FINAL PLAT OF
"HILLSIDE PARK"

RE: S/D 99-75 -- One-Step Final Plat of HILLSIDE PARK ADDITION

RE: S/D 99-75 -- One-Step Final Plat of HILLSIDE PARK ADDITION

CASE NUMBER: S/D 99-75 -- HILLSIDE PARK ADDITION

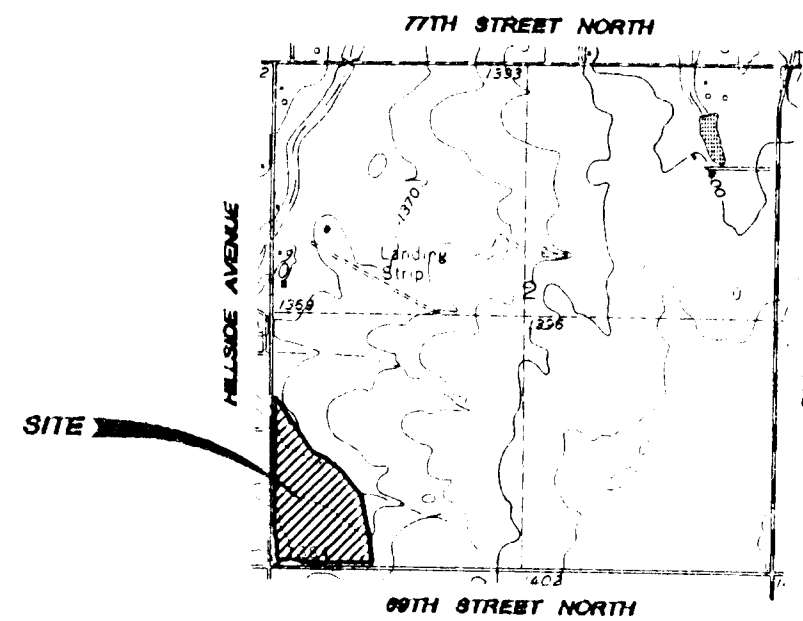
- C. County Engineering needs to comment on the status of the applicant's drainage plan. The drainage plan is approved.
- D. County Engineering needs to comment on the access controls. The face of the plat shall denote the access controls as referenced in the plat's text. The plat's text shall be revised to reference the "west" line of Lot 2. County Engineering has required 350 feet of complete access control from the section corner.

- E. The MAPC Chairman needs to be revised to reference "Francis S. Garofalo".

- F. If platted, the building setback may be reduced to 35 feet.
- G. For those reserves being platted for floodway purposes, a covenant shall be required which provides for ownership and maintenance of the reserves and shall grant, to the appropriate governing body, the authority to maintain the floodway reserves in the event the owner(s) fail to do so. The covenant shall provide for the cost of such maintenance to be charged back to the owner(s) by the governing body.

- I. The platting text shall include language that a drainage plan has been developed for the plat and that all drainage easements, rights-of-way, or reserves shall remain at established grades or as modified with the approval of the applicable City or County Engineer, and unobstructed to allow for the conveyance of stormwater.

- K. The applicant's engineer is advised that the Register of Deeds is requiring the name(s) of the notary public, who acknowledges the signatures on this plat, to be printed beneath the notary's signature.

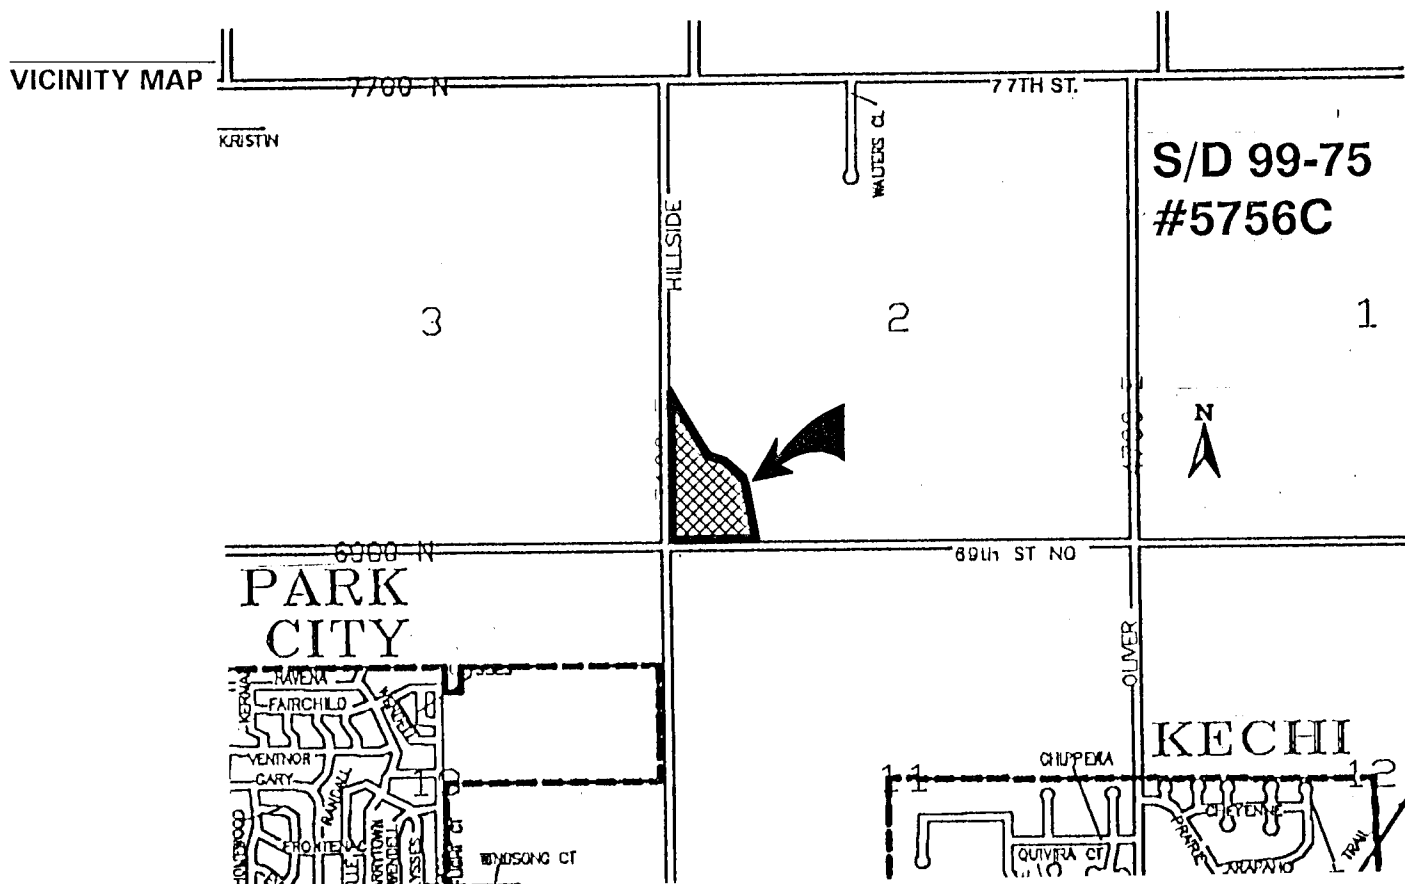
- C. County Engineering needs to comment on the status of the applicant's drainage plan. The drainage plan is approved.
- D. County Engineering needs to comment on the access controls. The face of the plat shall denote the access controls as referenced in the plat's text. The plat's text shall be revised to reference the "west" line of Lot 2. County Engineering has required 350 feet of complete access control from the section corner.

- E. The MAPC Chairman needs to be revised to reference "Francis S. Garofalo".
- F. If platted, the building setback may be reduced to 35 feet.
- G. For those reserves being platted for floodway purposes, a covenant shall be required which provides for ownership and maintenance of the reserves and shall grant, to the appropriate governing body, the authority to maintain the floodway reserves in the event the owner(s) fail to do so. The covenant shall provide for the cost of such maintenance to be charged back to the owner(s) by the governing body.

- I. The plat's text shall include language that a drainage plan has been developed for the plat and that all drainage easements, rights-of-way, or reserves shall remain at established grades or as modified with the approval of the applicable City or County Engineer, and unobstructed to allow for the conveyance of stormwater.

- K. The applicant's engineer is advised that the Register of Deeds is requiring the name(s) of the notary public, who acknowledges the signatures on this plat, to be printed beneath the notary's signature.
